SENSENICH PROPELLER CO., INC.

FAQ FOR SERVICE BULLETIN SB2016-06B

Figure 1. Hub Model 2A0 Series Revision "D" and earlier

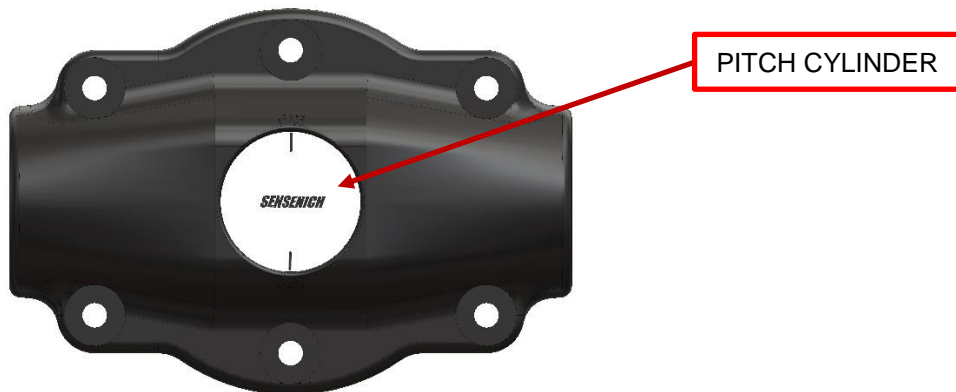
Affected hubs:

Models 2A0J5 and 2A0R5, revision "0", "A", "B", "C", and "D".

The first several years of hub production did not include a stamped model number on the part.

Identification is denoted by the presence of the white pitch cylinder.

The serial number last digit indicates the revision level: If the last digit is a number, then it is revision "0", otherwise there is a letter such as "A", "B", etc...

Revision "D" was the last hub revision which incorporated the pitch cylinder feature.

Figure 2. Hub Model 2A0 series Revision "E" and later

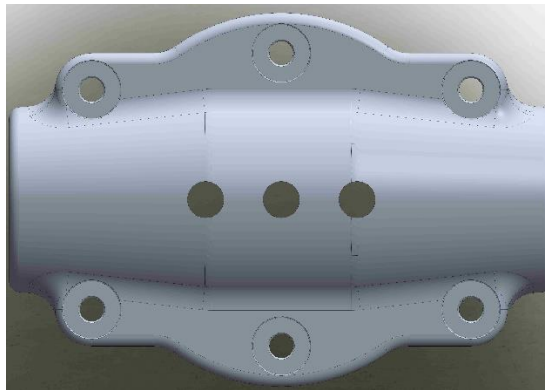
- Revision "E" or later 2A0 series hubs with three ½" diameter holes in the hub cover half are not affected. See Figure 2.

Figure 3. Hub Models 2A1R5 and 3A0B7, respectively

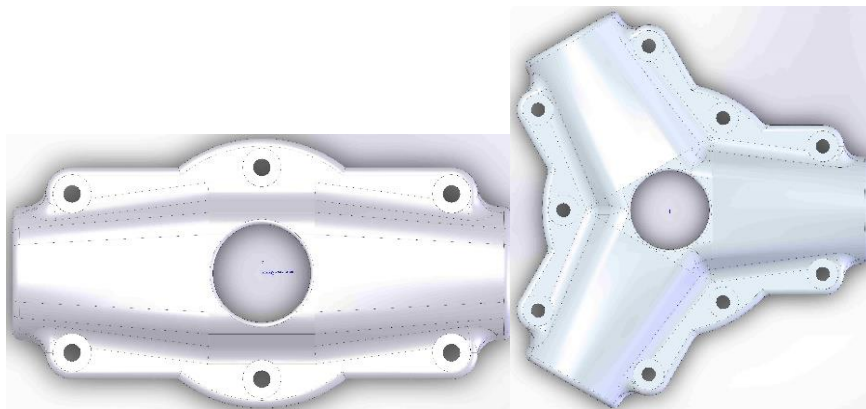
- Model 2A1R5 and 3A0B7 hubs with long blade shanks are not affected. While they do incorporate the white pitch cylinder, the blade retention geometry is significantly longer and different from the compact 2A0 series so that this service bulletin does not apply. See Figure 3.

Figure 4. Cracks start near pitch marks and grow outwards. Inspection inside the hub cover is required.

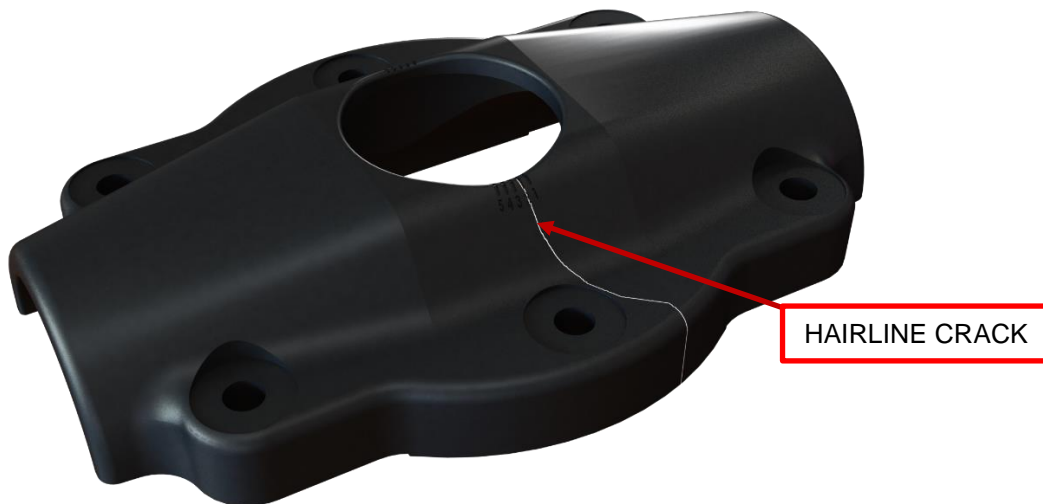
- The hub cracks typically start at or near the pitch marks on the sides of the central hole, and grow outwards towards the hub sides. They are hairline cracks which are very difficult to see with the naked eye. We recommend using very good lighting, a 10x magnifying glass and inspecting the inside of the pitch cylinder hole in the hub cover next to the pitch marks.
- See Figures 4 through 6 below. Figure 4 shows the best location for inspection, on the inside of the hub cover pitch cylinder hole.
- The hub cover must be removed from the propeller assembly for thorough inspection inside the pitch cylinder hole. *Inspection of the hub exterior is not adequate.*
- Hub color/plating does not appear to be a factor, but the black anodize makes inspection more difficult.
- This inspection must be performed every 50 flight hours or annually, whichever comes first.

Figure 5. Unattended cracks may progress to edges of hub cover half.

Figure 6. Nord-Lock Lock Washer

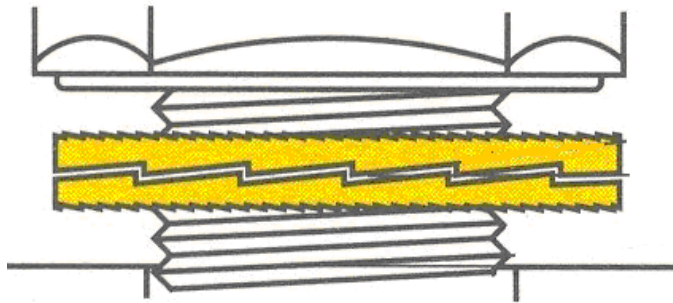
Nord-lock washers work in pairs with the ramped sides facing each other. See Figure 6.

During loosening, the Nord-lock washers may click loudly; this is normal. Inspect Nord-lock washers on the inside cam surfaces and outside serrations. Replace washers with excessive wear.

Lubricate acceptable washers with a light coating of engine oil or equivalent.

Figure 6. Clamp Bushing Engagement into Hub Cover

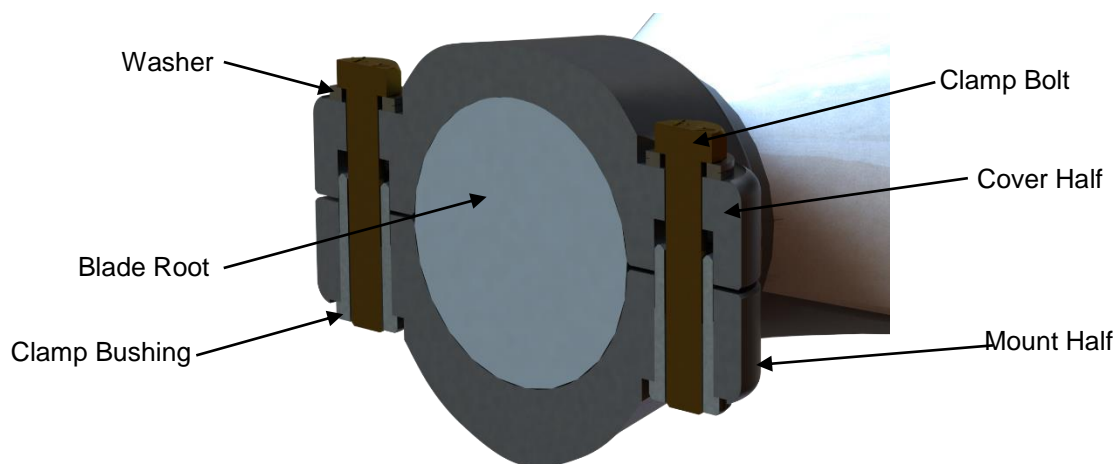
One design element which increases the retention safety for the 2A0 hub series is the incorporation of threaded clamp bushings. These bushings are press fit in the hub mount half and engage the hub cover half when the propeller blades are pitched and clamp bolts fully torqued. This ensures that the propeller clamp bolts do not carry any shear loads even if the hub cover cracks into two pieces.

NOTE: The clamp bushings provide blade retention backup *and do not change the 50 hour inspection interval for this service bulletin.*
